# CITY OF TEMPLE, TEXAS AVENUE G PUMP STATION IMPROVEMENTS

## RELEASED FOR CONSTRUCTION

SHEET NO. **G-08**  
 OF **10** SHEETS

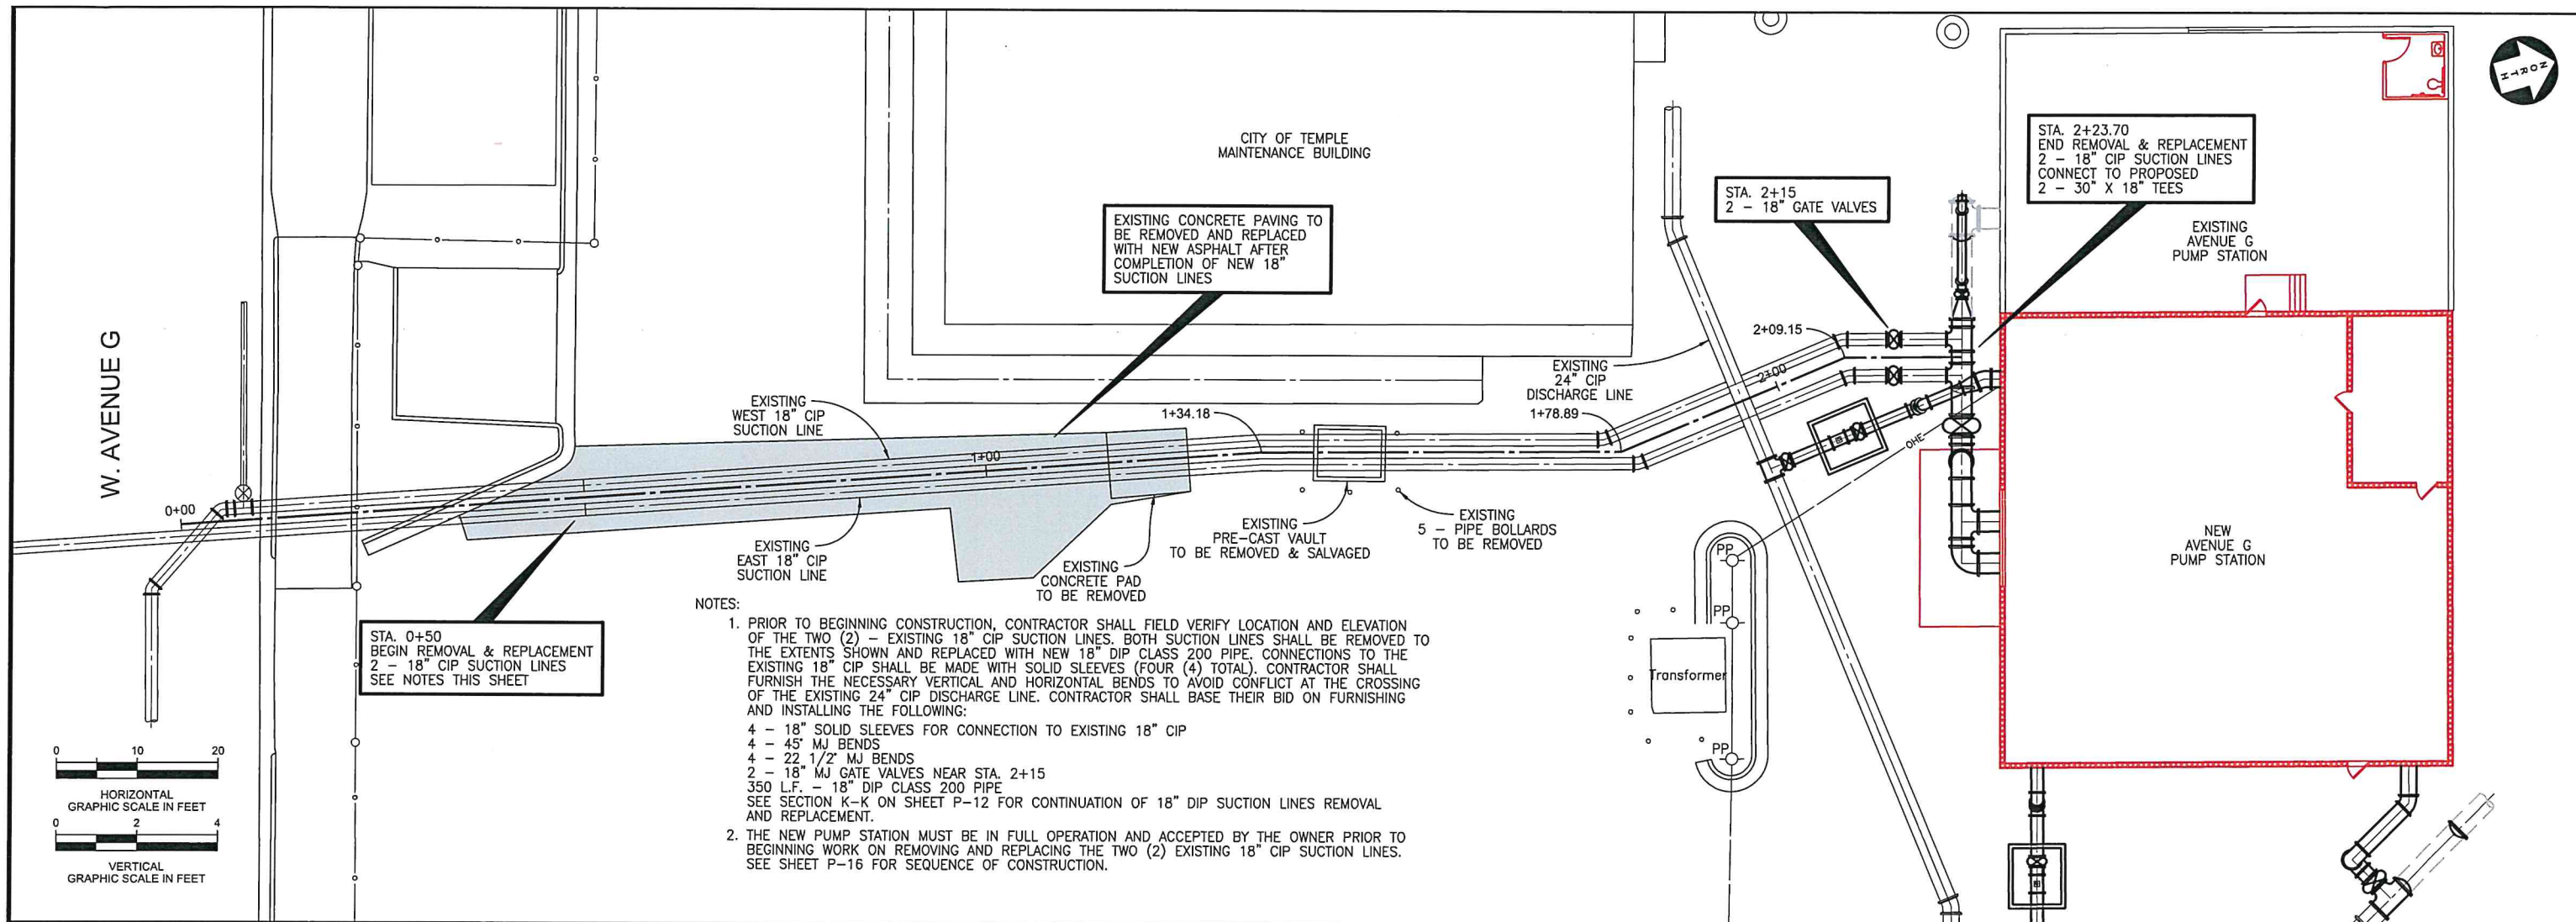
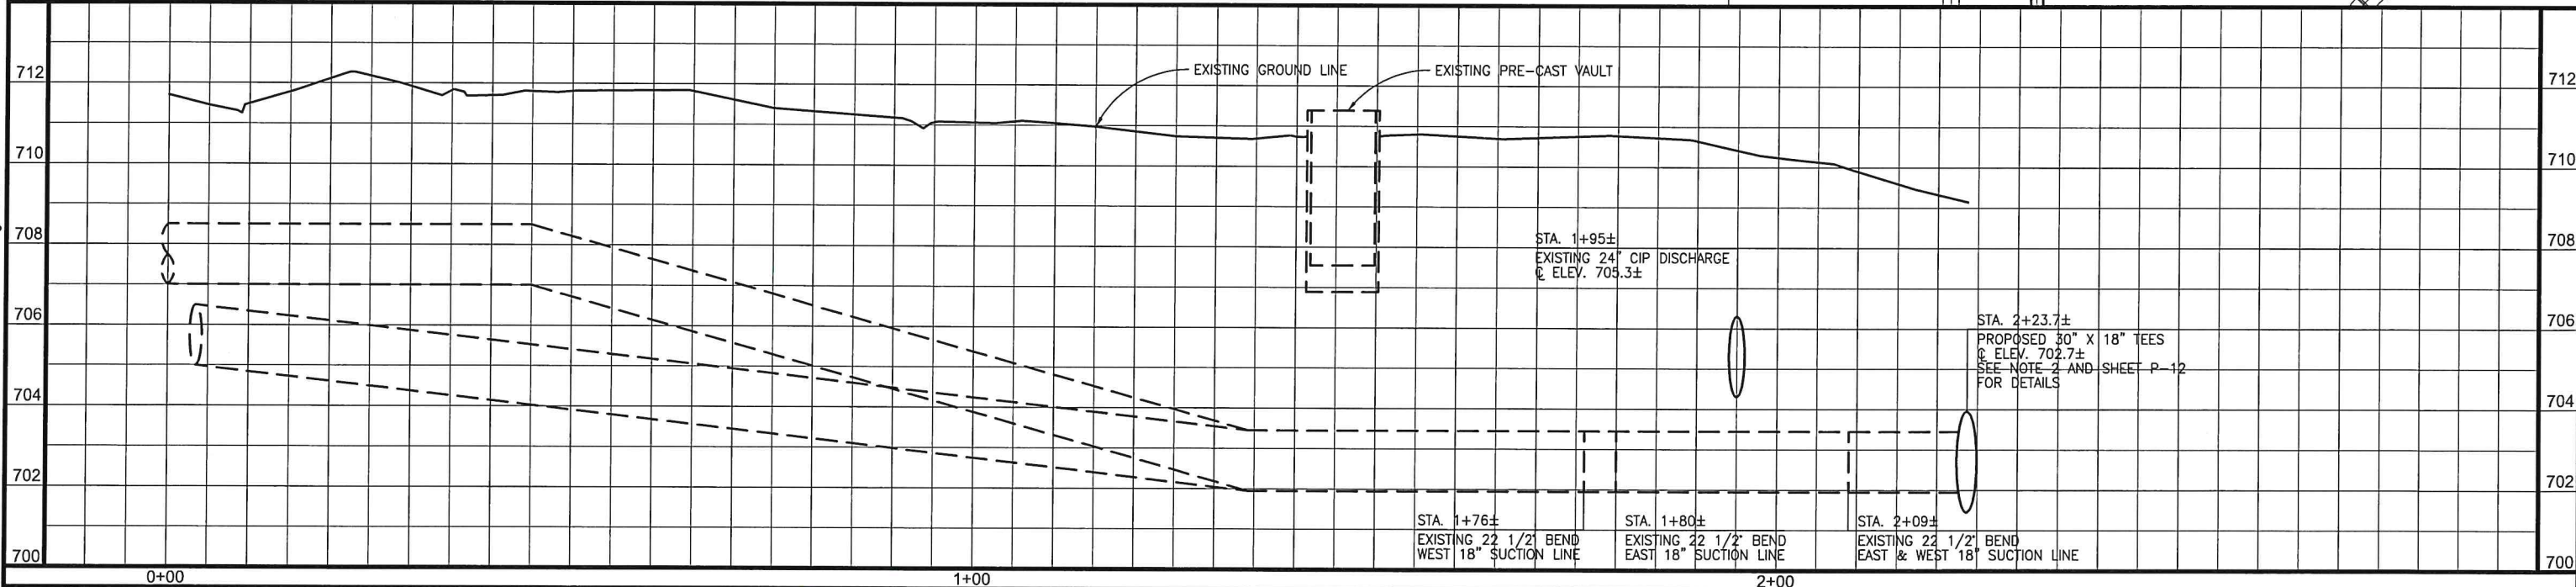
1. Refer to sheet G-08. Revised Note 1 for proposed 24" suction line, not 30" in the sentence, "The proposed wet tap and gate valve for connecting the proposed 24" DIP suction line to the existing 30" C-301 suction line shown on sheet P-07 shall be performed by certified technicians with Thompson Pipe. Attached is revised Sheet G-08 dated September 16, 2022, which reflects these changes.

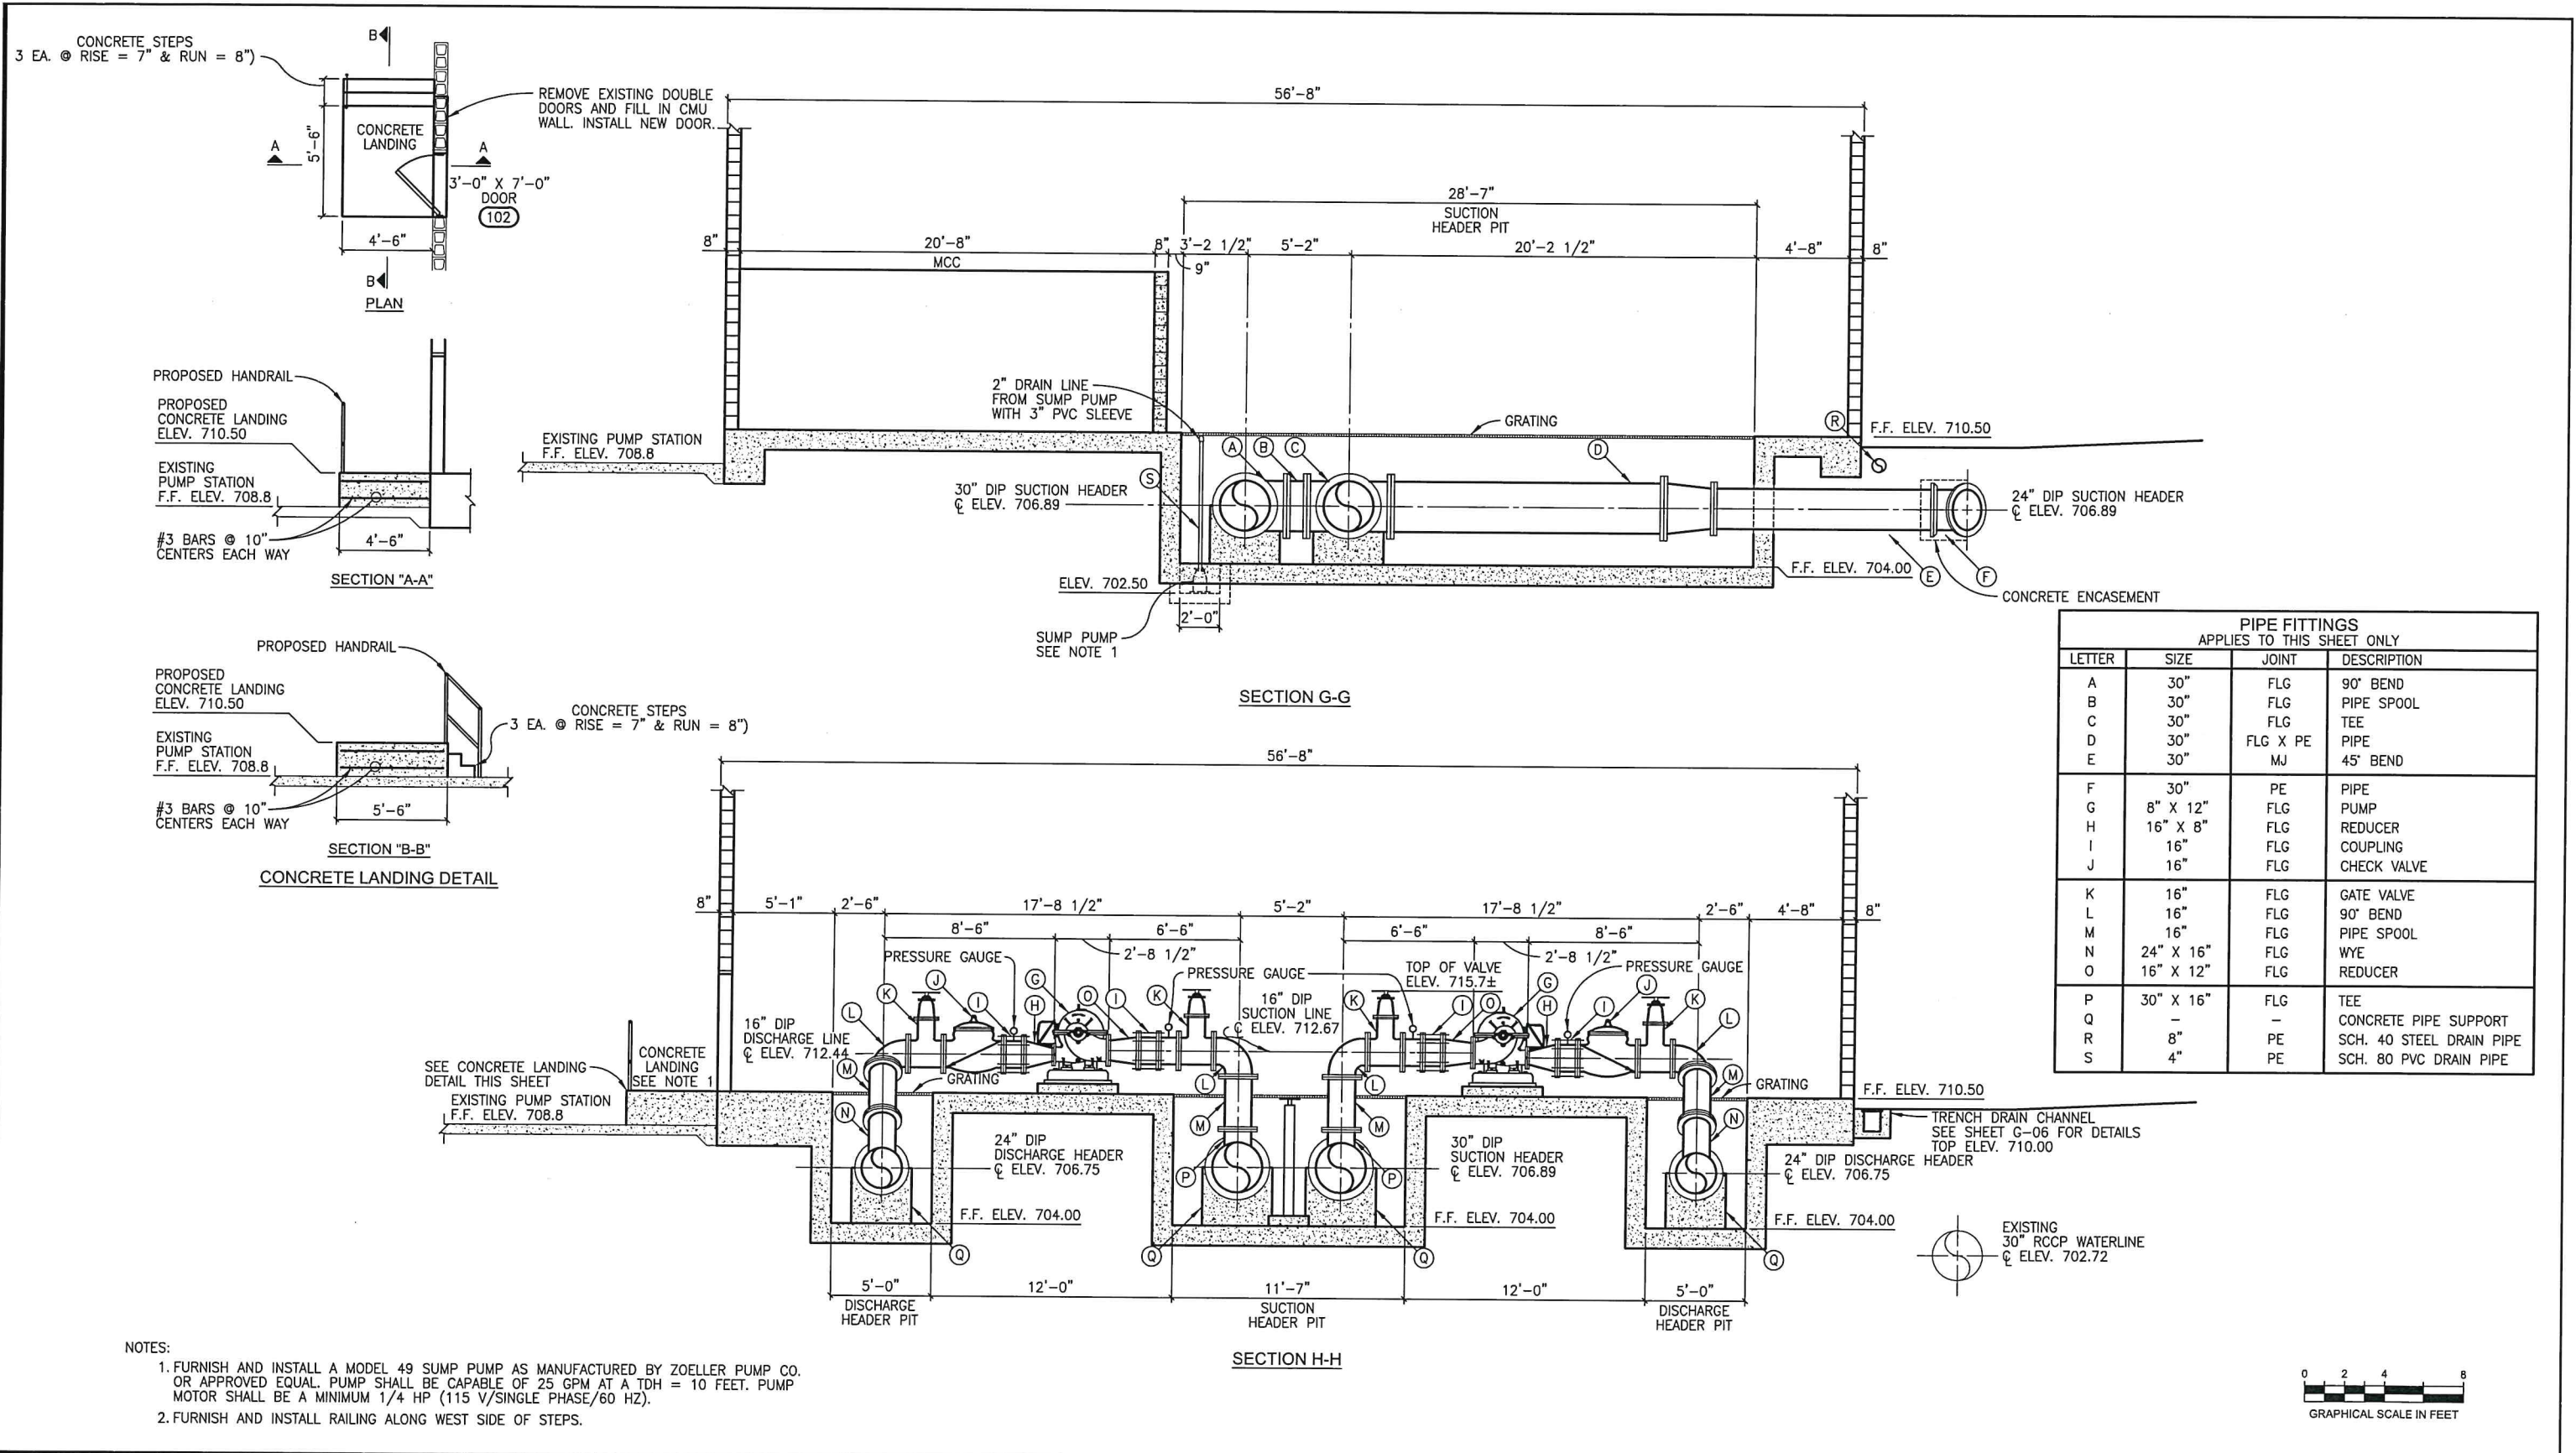
2. Refer to Sheet P-11. In Section H-H change the suction pipe reducers labeled "H" to Eccentric Reducers. The flat side of the eccentric reducers shall be faced upward to prevent air pockets from forming on the suction side of the pump.

5. Refer to Sheets P-11 thru P-13. Proposed couplings shown on these plan sheets shall be Flanged Dresser Style 128 as manufactured by Smith Blair or approve equal.

SECTION K-K

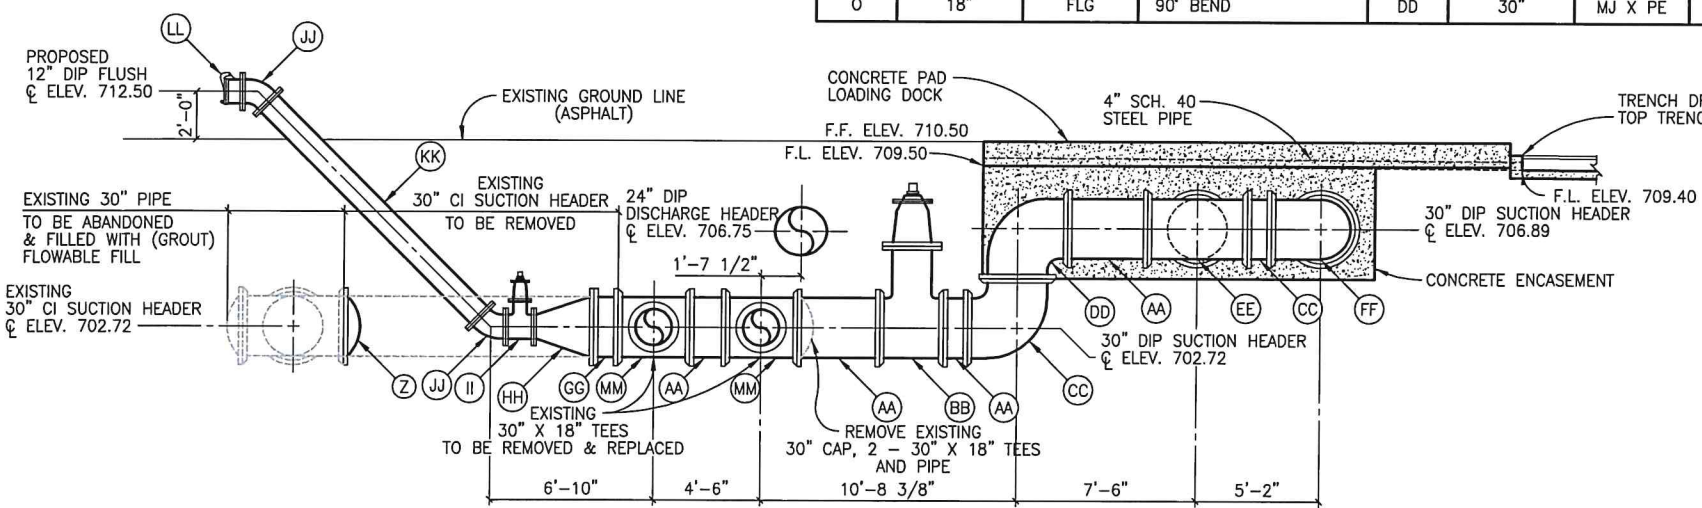
1. General: Flap Valve shown in Section K-K on Sheet P-12 and labeled "LL" shall be a 12" Model A25406 as manufactured by Troy Valve or approved equal.

\* INDICATES FIELD WIRING REQUIRED BY CONTRACTOR  
**2 RTU SCHEMATIC**  
 E6.0 SCALE: NTS

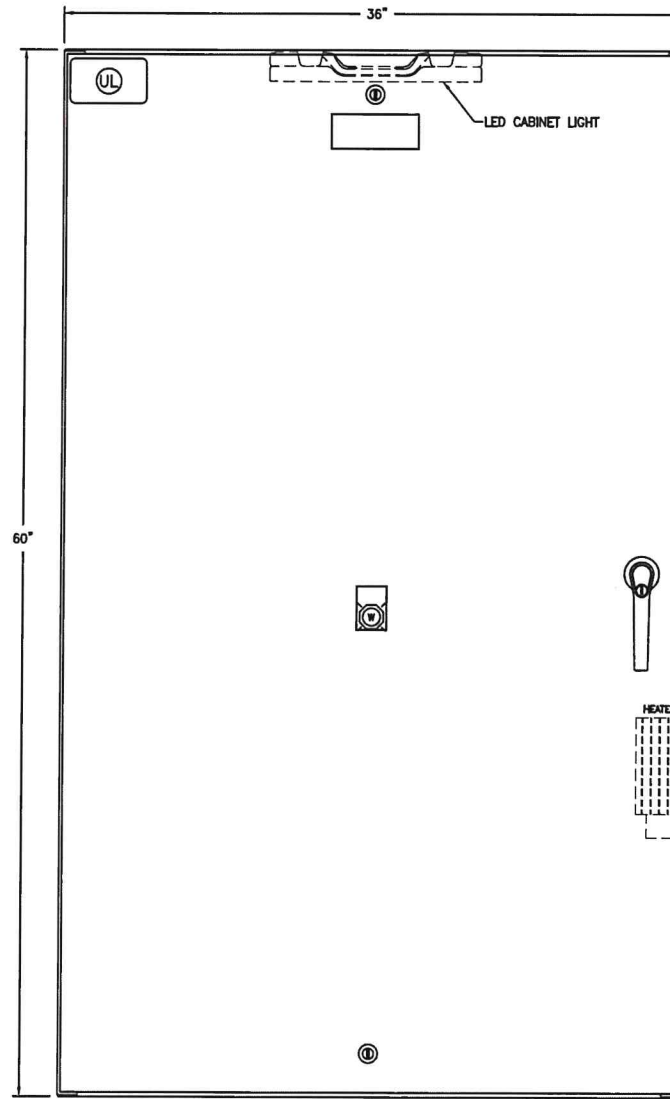
6. Refer to Sheet E6.0.
  - a. Delete the two (2) Phoenix Radios shown on the RTU Schematic. These were shown in error.
  - b. The radio shown in the RTU Schematic shall be a Phoenix Model #2901540 or approved equal.
